**ANDERSEN AFB
GUAM**

**Modified Closure Plan
for the Landfill Area**

March 28, 1991

CLOSURE MODIFICATIONS

Site Map: AAFB Landfill

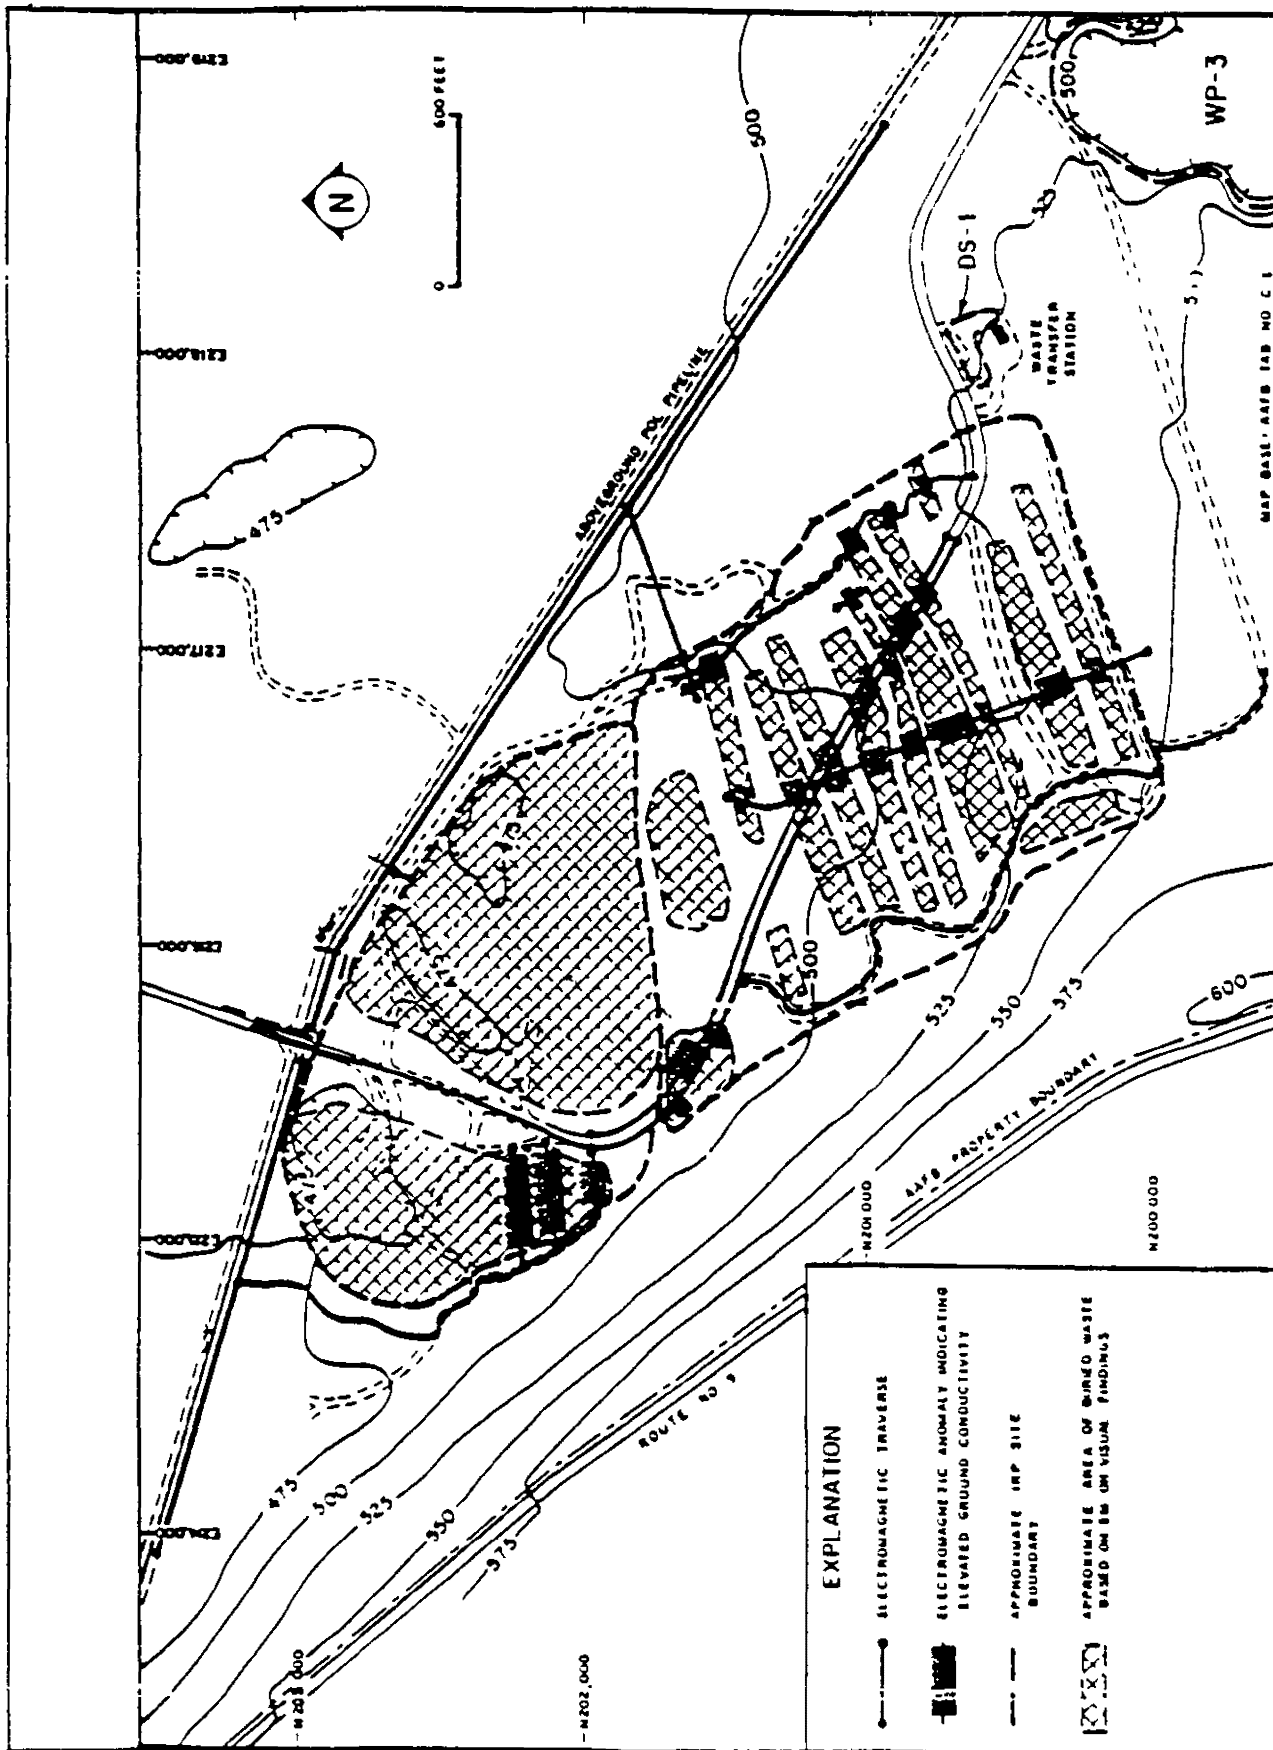
1. The U.S. Air Force shall cover the waste portion of the Landfill (see attached map, Attachment IV) per the following performance standards (Items #2 through #23 of this Plan). The U.S. Air Force may cover only those cells that received hazardous waste if they are adequately defined in areal extent. The Air Force shall submit documentation, satisfactory to the Guam E.P.A. that defines the area(s) within the landfill that received hazardous wastes or use geophysical studies and direct sampling of soils and waste materials to determine vertical and horizontal extent of waste and contaminated soils and submit the results of sampling and studies to Guam E.P.A. for the Administrator's approval. Prior to commencement of sampling and analytical activities, A.A.F.B. must submit a S/A Plan for soils and waste materials to Guam E.P.A.'s Administrator for review, modification and/or approval. The Plan must be prepared following the "Preparation of a U.S.E.P.A., Region IX Field Sampling Plan for Private and State-Lead Superfund Projects" (#9QA-06-89, April 1990). Commencement of the aforementioned activities are contingent upon approval of this Plan. Should the U.S. Air Force choose to adopt this approach, then [pursuant to Part VII.A. of Guam's Hazardous Waste Management Regulations (40 CFR 265.112 (c))], the Air Force shall submit an amendment request to the Administrator for approval, sixty (60) days prior to this proposed change.
